APPENDIX A-2:
Correspondence Log

Correspondence with First Nations Groups

We have received the draft Environmental Study Report (ESR) for the above noted environmental assessment. Our understanding is that the preferred alternative site is site 2 (SL 22 MTS). We provide the following comments on the ESR below for your consideration. Comments on the appendices will be provided in a separate letter following our review once the appendices are provided to the MOECC.

Attachment 1: Seaton MTS Constraints in Vicinity of Preferred Site

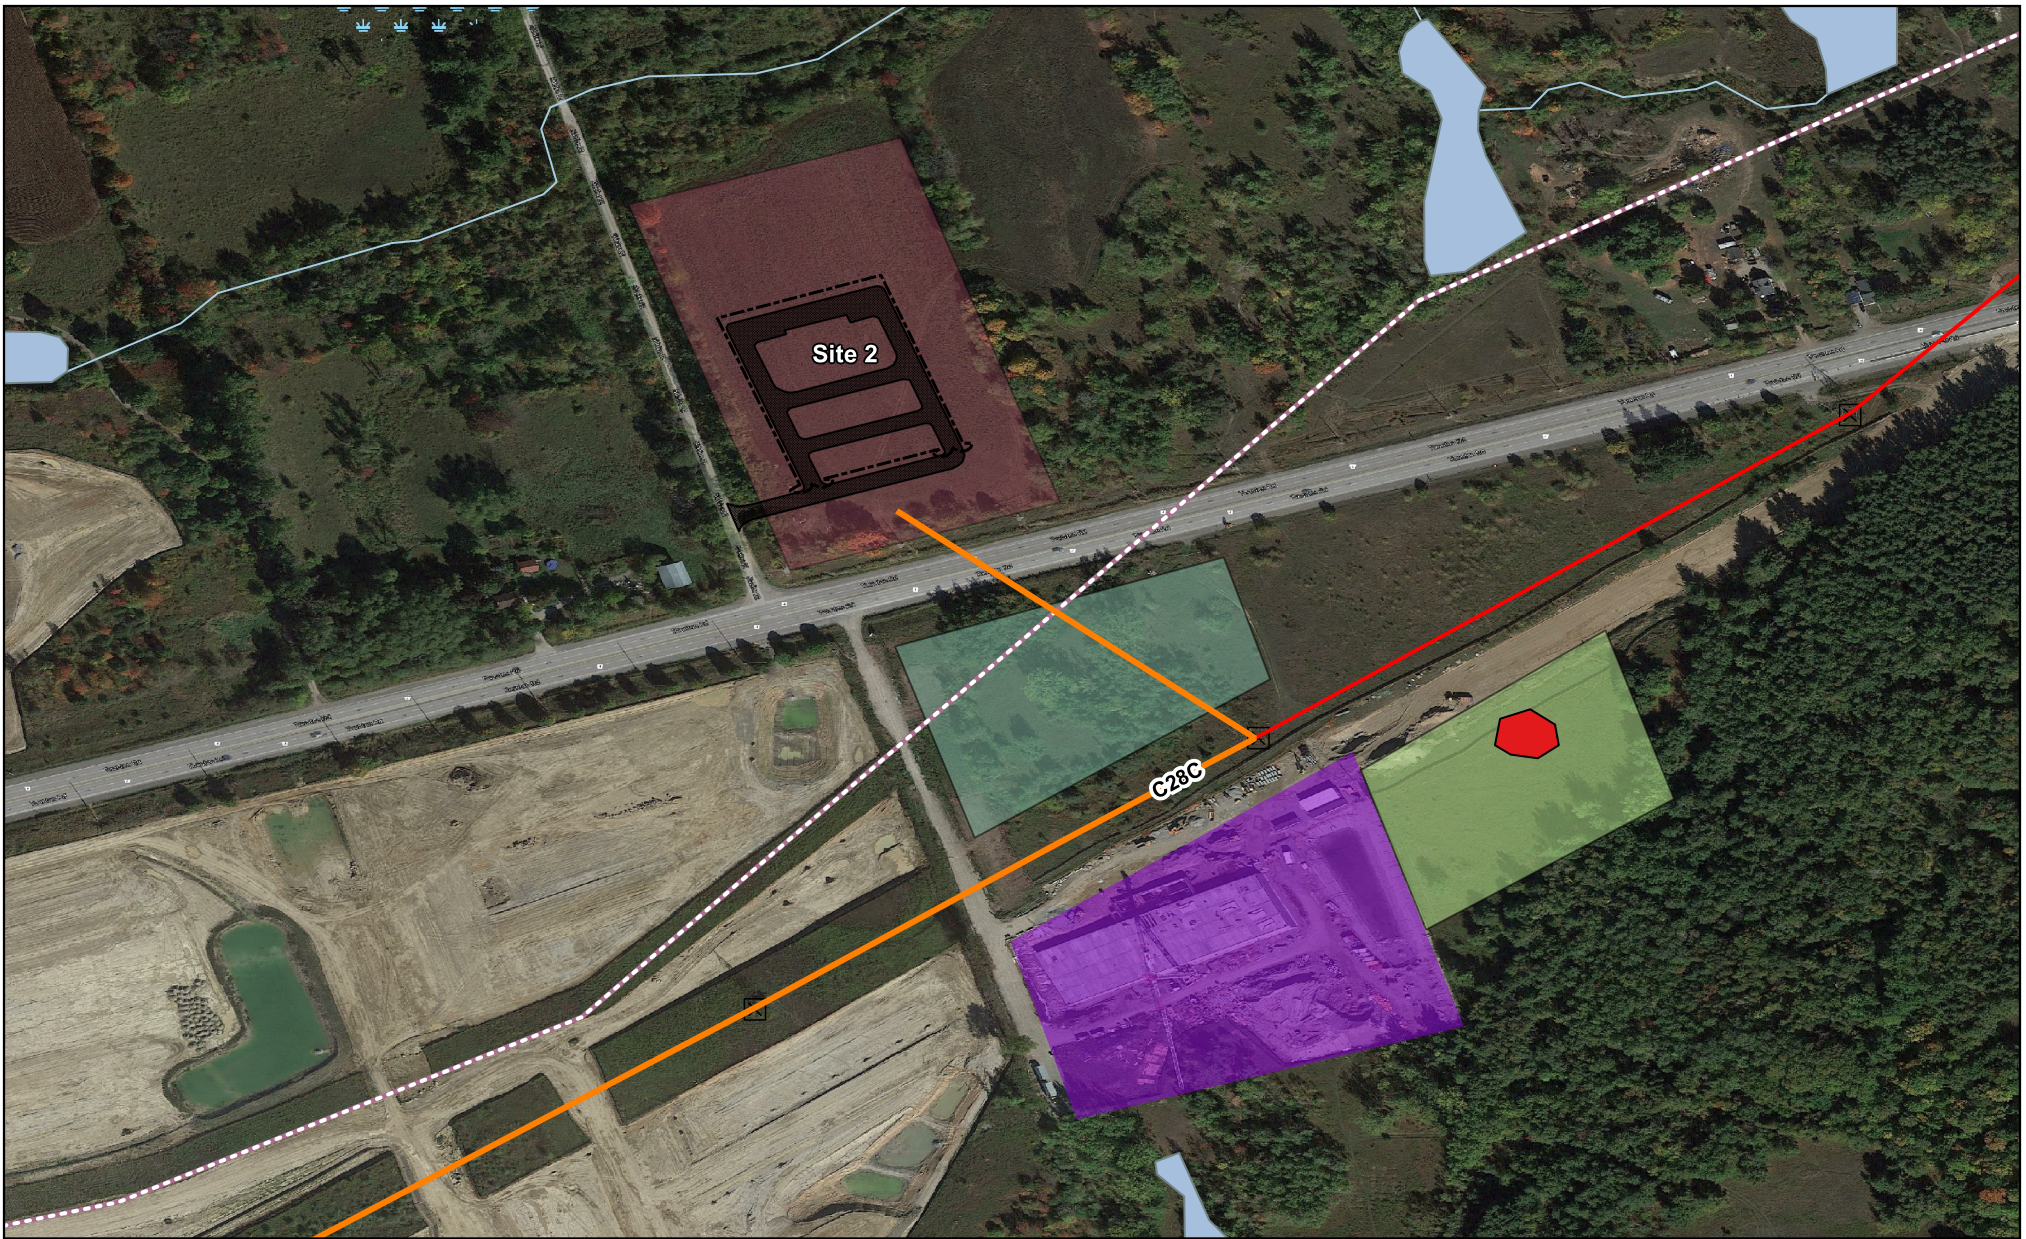
1. *Please note that TRCA staff did not agree to the locations suggested in the MESP in figure D4.1 and at the time of review requested additional station locations be explored outside of the NHS. It is our understanding that through this EA process that some of the locations identified in the MESP have changed. As a result, the EA should address the following:*
